re: Geotechnical Design Summary Details
Proposed Residential Building
2458 Cleroux Crescent – Ottawa, Ontario

date: July 20, 2023

file: PG5973-MEMO.02

Grading Plan Review

PG5973-MEMO.02 - FIGURE 1 LIGHTWEIGHT FILL RECOMMENDATIONS

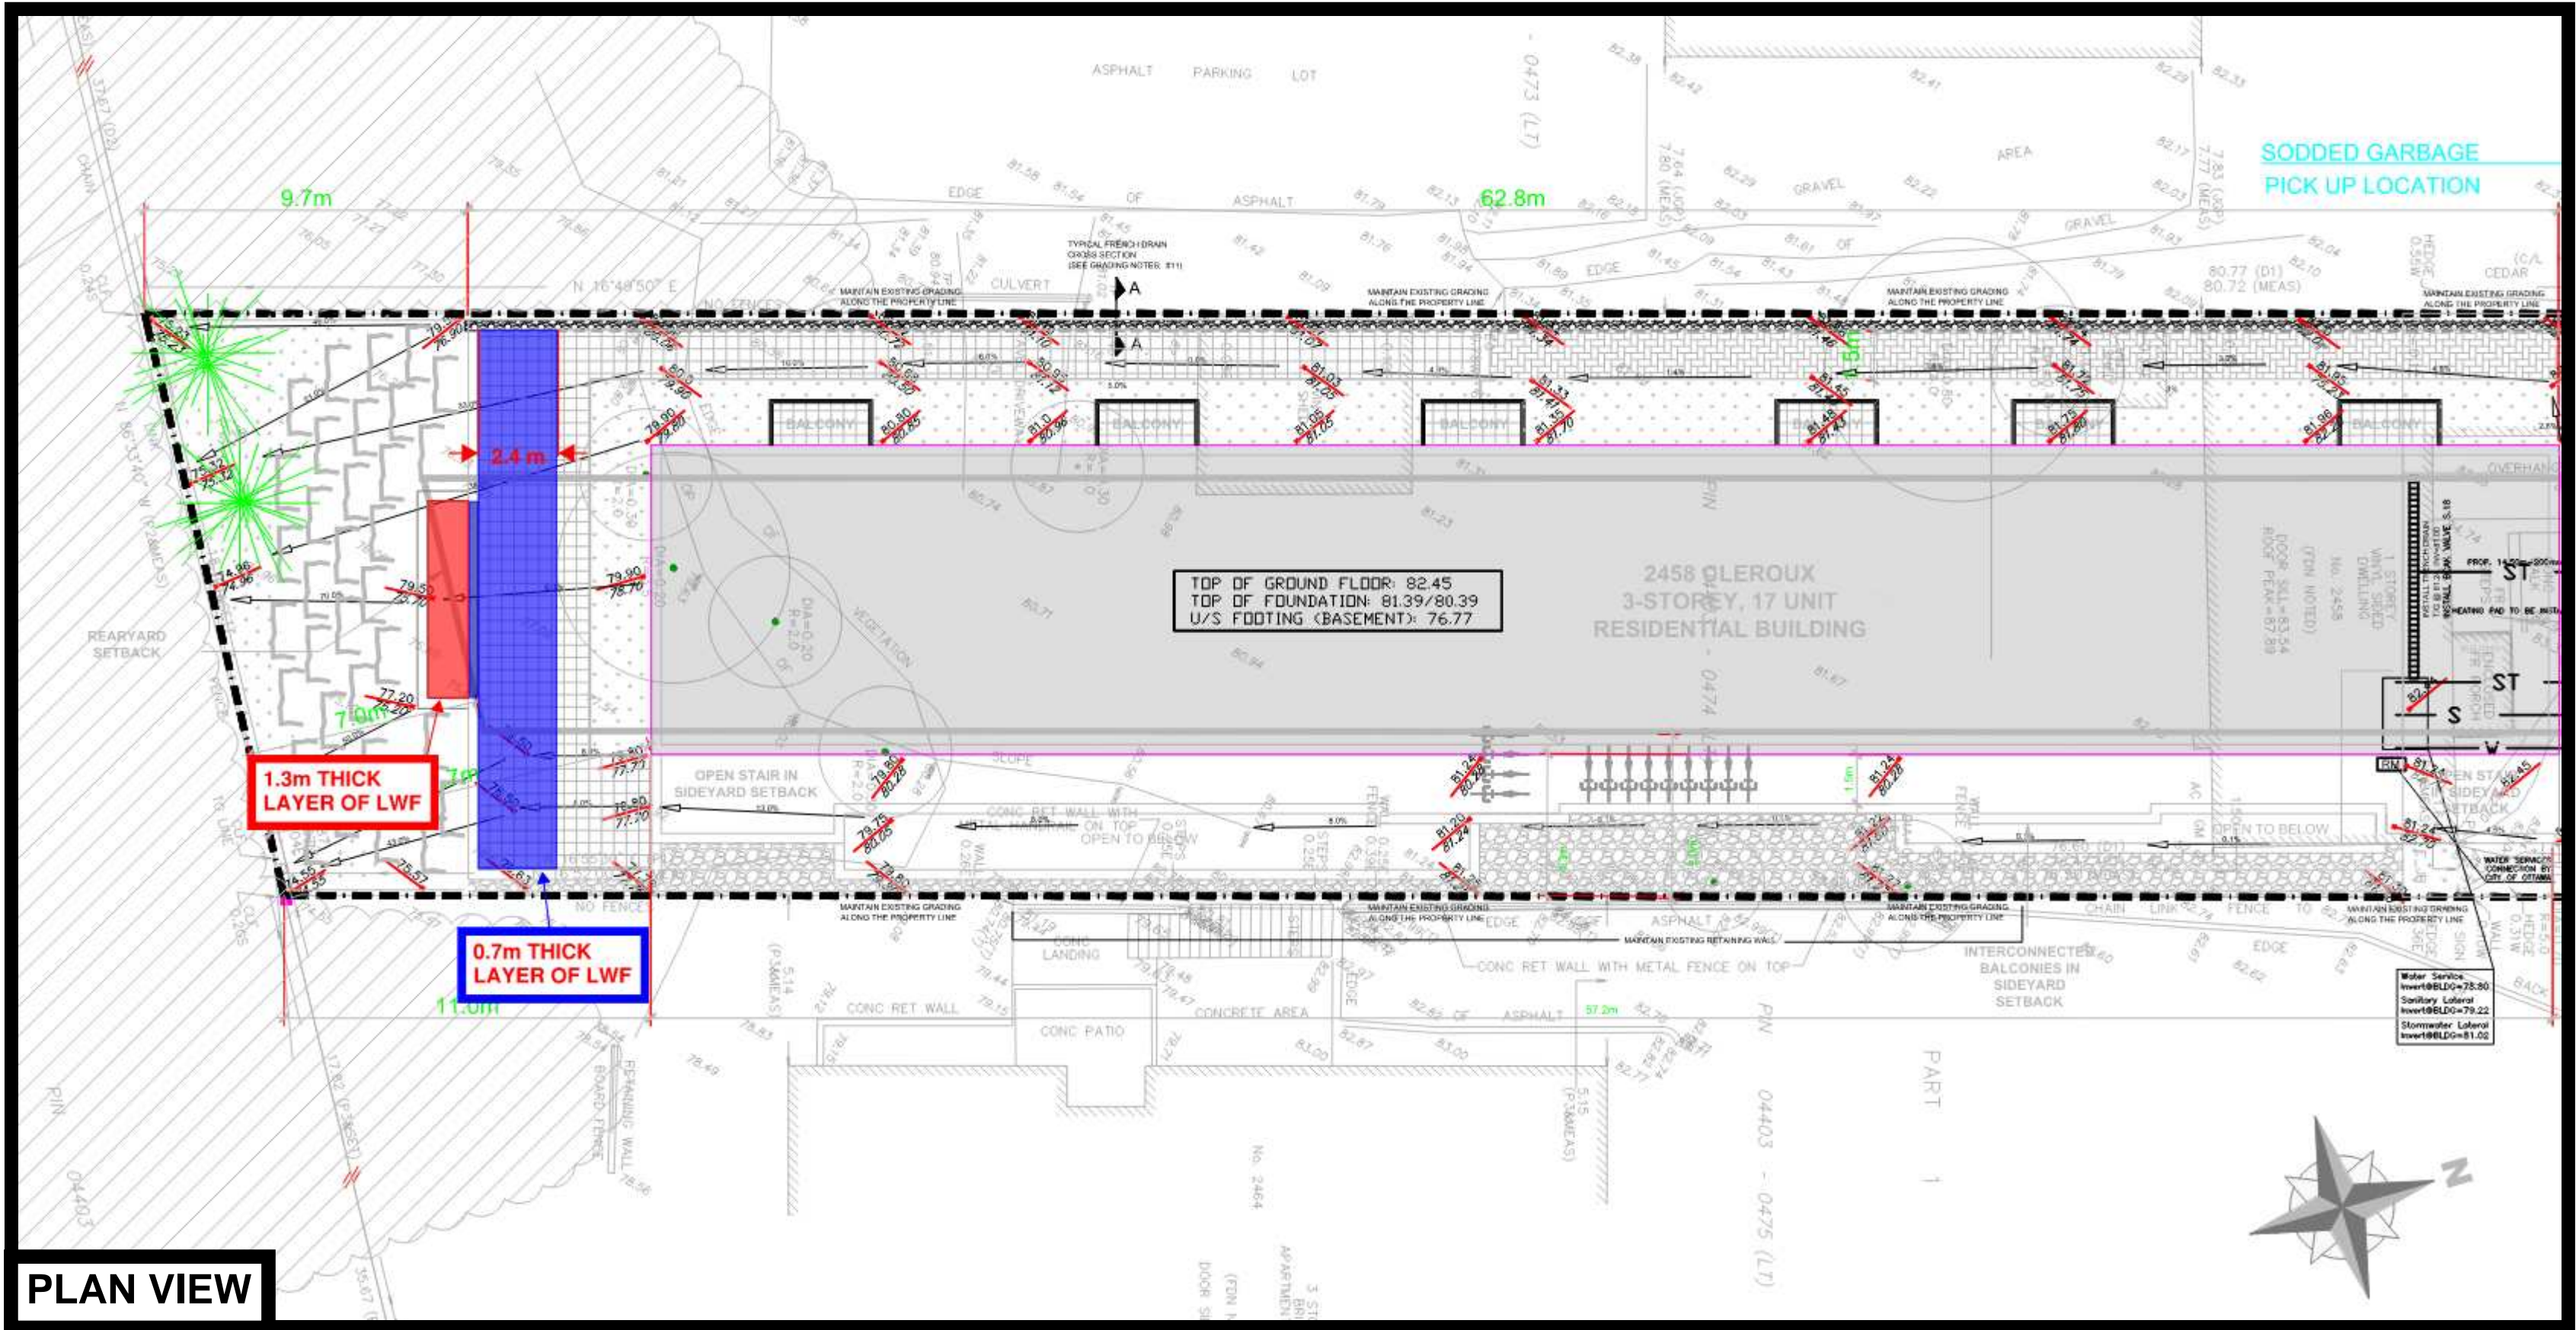
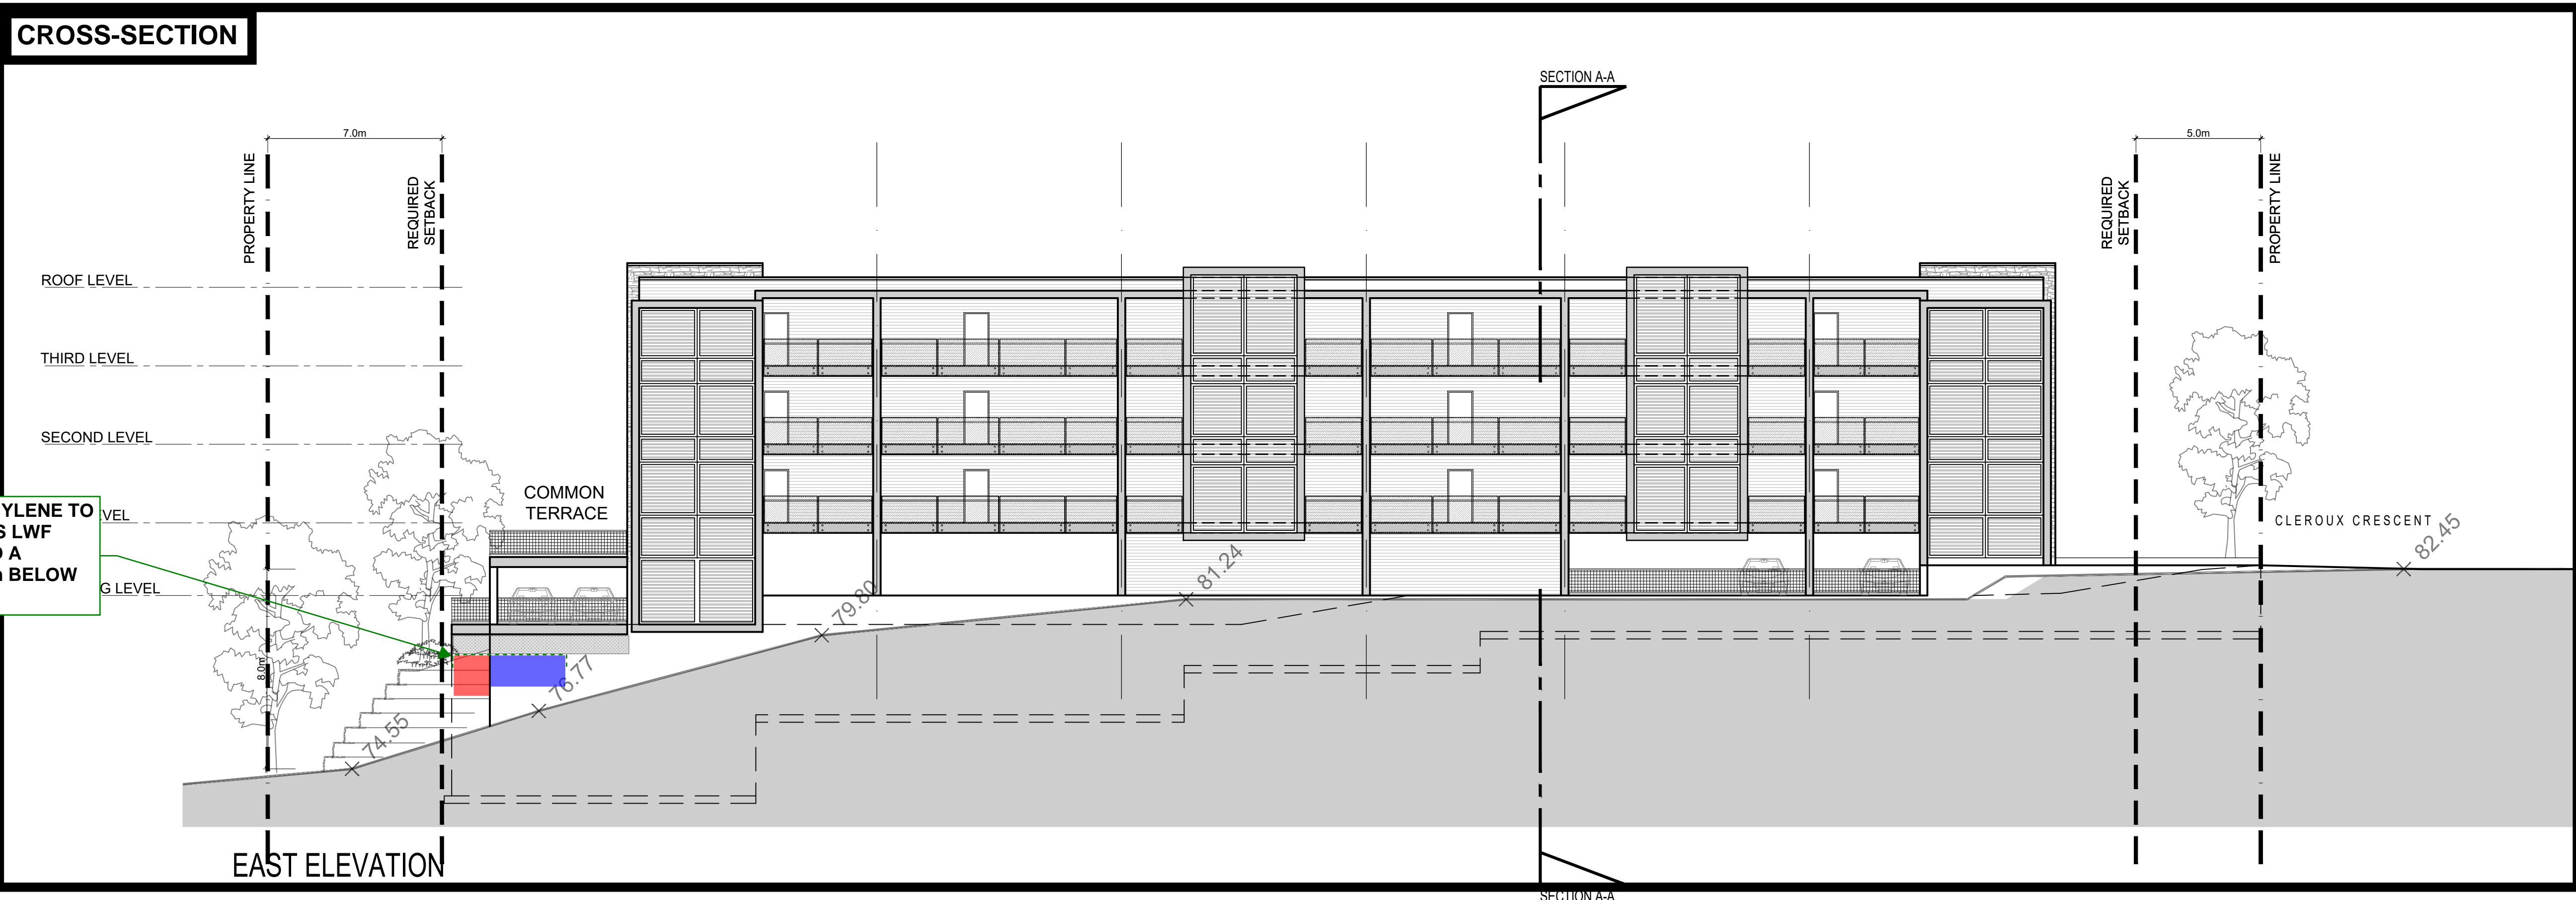
Further to our review, the proposed finished grade along the rear side and throughout the parking area of the proposed building would result in an exceedance in the recommended permissible grade raise restriction provided in the aforementioned Geotechnical Report. Lightweight fill (LWF) has therefore been recommended to accommodate the proposed grading throughout and along the rear portion of the building.

The LWF should consist of EPS (expanded polystyrene) geofoam blocks consisting of a minimum EPS type 19 block for these purposes. The LWF should be placed throughout the indicated area of the building footprint a minimum of 500 mm below the subslab fill layer. The entire LWF layer footprint is recommended to be covered with a layer polyethylene which should further extend a minimum of 300 mm below the LWF layer surface. Placement of LWF should be upon a leveled surface and reviewed at the tie of construction by Paterson personnel.

Reference should be made to Figure 1 – Lightweight Fill Recommendations attached to the end of this memorandum for a summary of the proposed installation methodology information.

IT IS RECOMMENDED THAT LIGHTWEIGHT FILL (LWF) BE PLACED THROUGHOUT THE GRADE RAISE FILL WITHIN THE PARKING LEVEL AS DEPICTED HEREIN. THE LWF IS RECOMMENDED TO CONSIST OF EPS GEOFOAM BLOCKS CONSISTING OF A MINIMUM EPS TYPE 19. THE LWF BLOCKS SHOULD BE COVERED WITH A LAYER OF POLYETHYLENE AND A MINIMUM THICKNESS OF 500mm OF CRUSHED STONE. PLACEMENT OF THE BLOCKS IS RECOMMENDED TO BE REVIEWED AT THE TIME OF CONSTRUCTION BY PATERSON PERSONNEL.
